VIRGINIA ELECTRIC AND POWER COMPANY  
RICHMOND, VIRGINIA 23261

Mr. Harold R. Denton, Director  
Office of Nuclear Reactor Regulation  
Attn: Mr. A. Schwencer, Chief  
Operating Reactors Branch No. 1  
Division of Operating Reactors  
U.S. Nuclear Regulatory Commission  
Washington, D. C. 20555

In your letter of July 20, 1979 additional information was requested on the use of high strength maraging steel in the reactor coolant pump supports. Enclosed herewith are the answers to your request for additional information.

QUESTION 1: Provide details of inspections performed on the monoball assemblies prior to installation into the plant. Provide significant results of any inspections. Include the threaded connection.

DRAWING NUMBER 11448-FM-53C

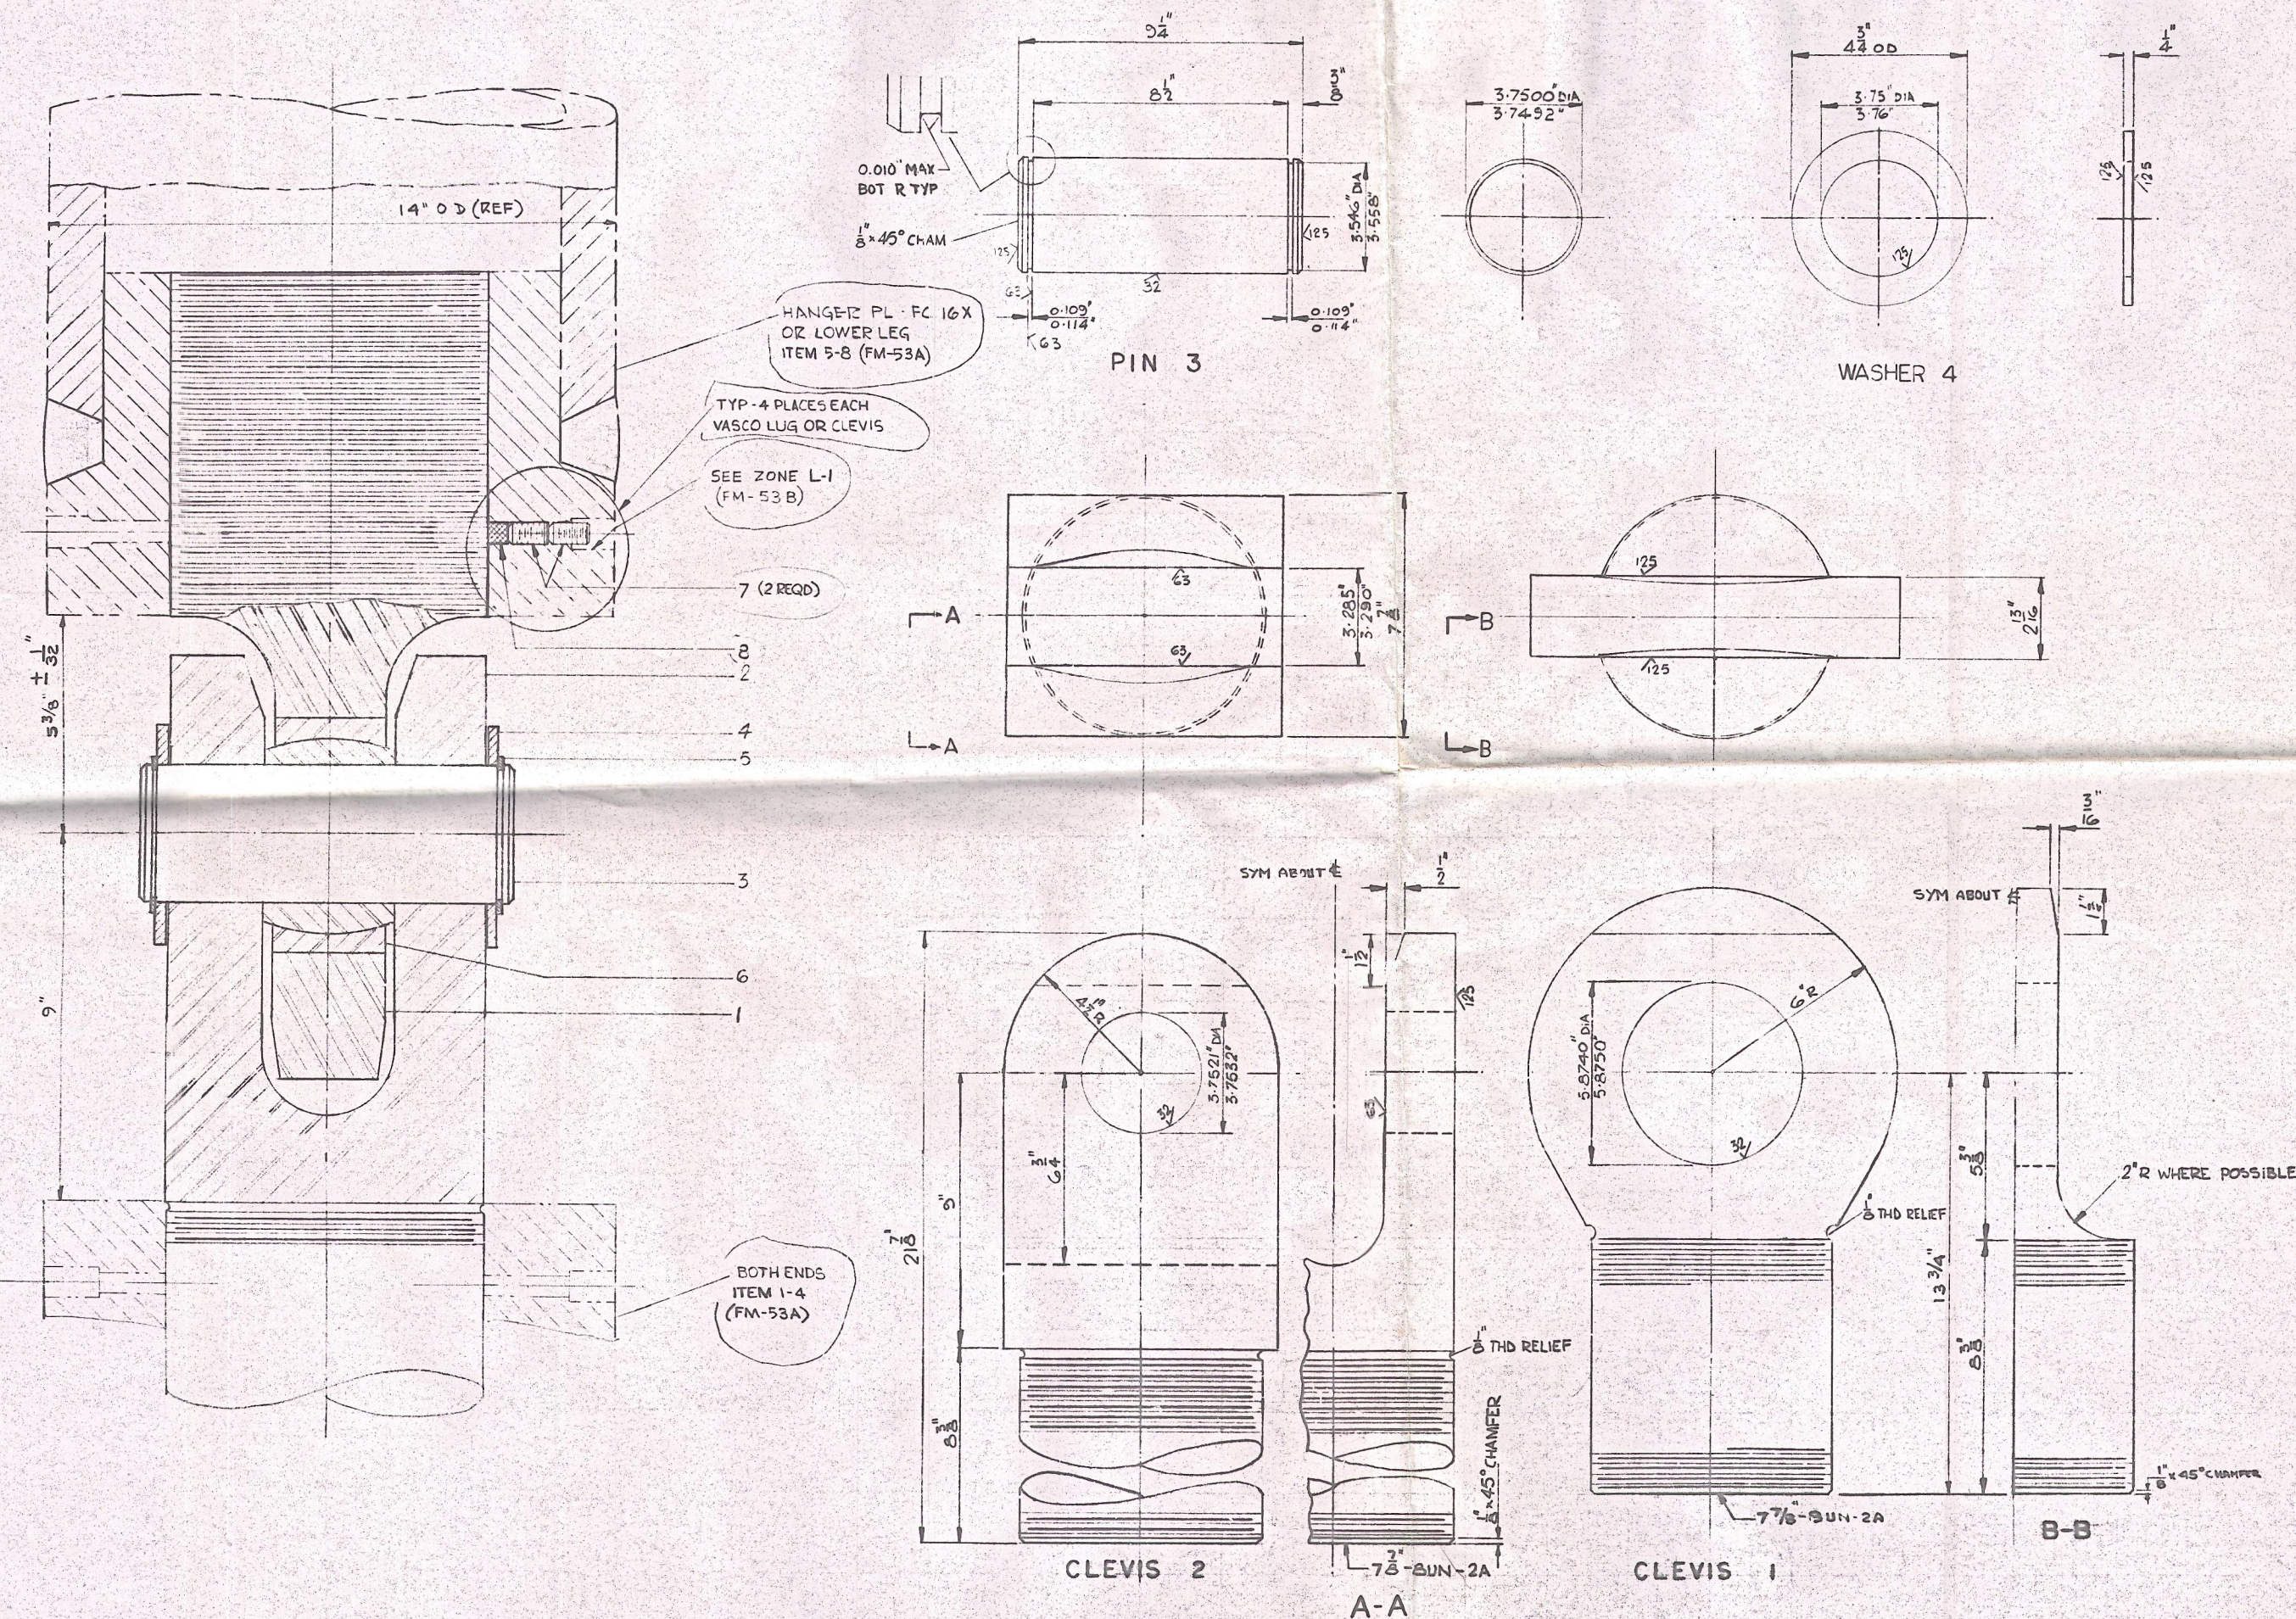
QUESTION 3: Provide any alternative NDE methods available which could be used to inspect those areas of the monoball assembly not accessible except by disassembly.

The maximum stress occurs in the lug and clevis (items 1 & 2 in drawing 11448-FM-53C, attached to response to question 5) at the hole where the pin fits. The stress is very local in nature and drops off rapidly away from the hole.

RESPONSE: NDE of the inaccessible parts of the monoball assemblies is not warranted when taking into consideration the stress levels in that assembly. The areas of the monoball assembly which are not accessible are also the least stressed. As an example, the maximum shear stress in the threaded portion of the monoball assembly is only approximately 2400 psi.
